## Southeast Rockford Source Control Operable Unit Focused Feasibility Study Volume I of III

Re: L2010300074 Winnebago Co.  
Southeast Rockford Groundwater Contamination  
Amendments to Final Feasibility Study Report  
Superfund/Technical Reports

## MEMORANDUM

Following the completion of the Feasibility Study, several minor errors have been identified (i.e. typographical errors, etc.) within the report. In addition, several alternatives described within the report have been slightly modified affecting the final cost for that alternative.

FIGURE No. 7-2  
SOUTHEAST ROCKFORD SOURCE CONTROL OPERABLE UNIT  
ROCKFORD, ILLINOIS

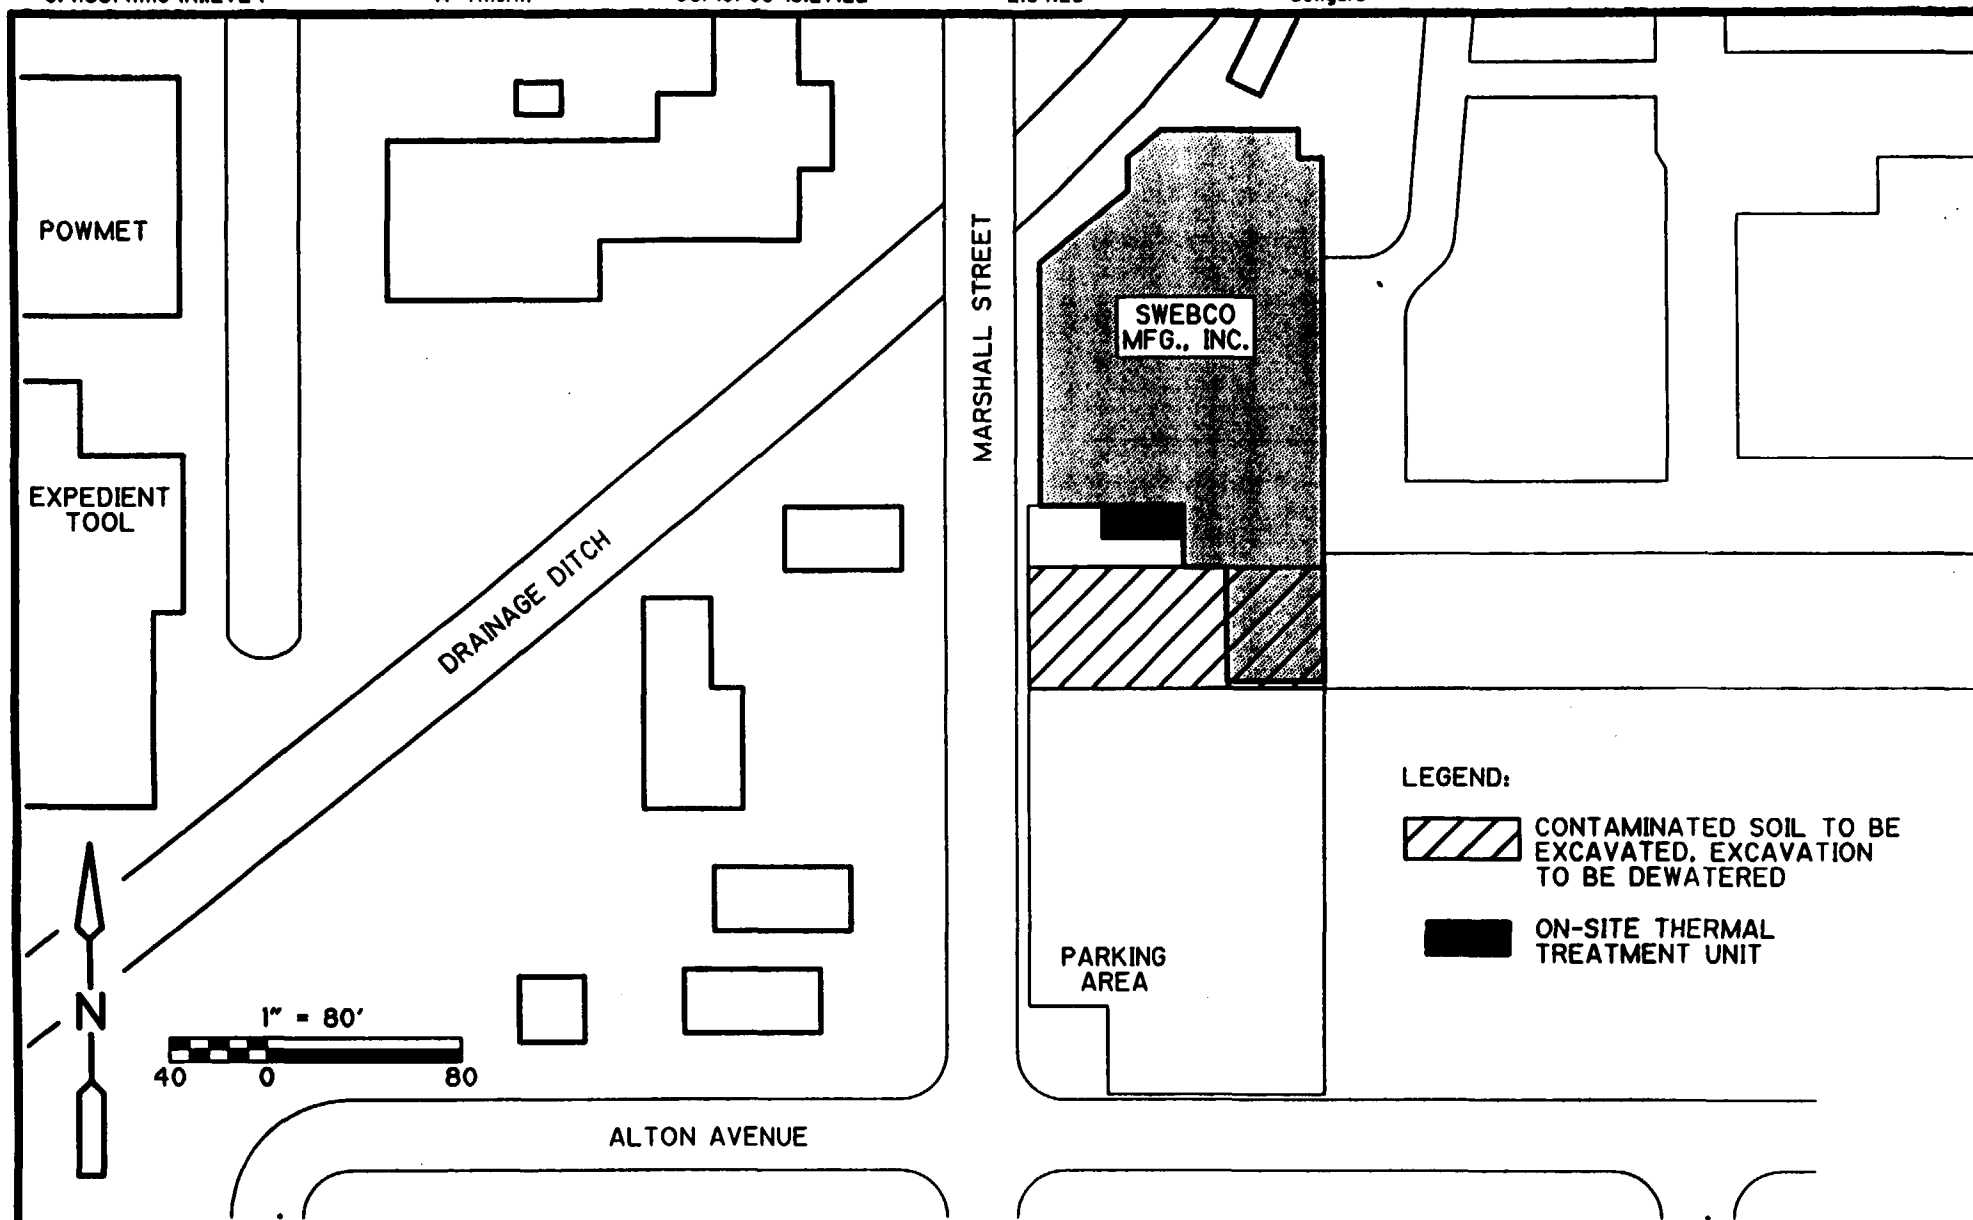
Added Text	Page 7-15; Following first complete paragraph	"It is anticipated that contaminated soils are located beneath the existing building structure on the property. During excavation of contaminated soils, a portion of the building may have to be demolished and shipped off site for disposal. Following completion of the excavation and treatment of contaminated materials, any portions of the building that were demolished could be replaced."
------------	---	---

**SOURCE AREA 4**  
**ACTIVE SCS-4D REVISED 1: PARTIAL DEMOLITION, EXCAVATION, AND ON-SITE THERMAL TREATMENT**  
**COST SUMMARY**
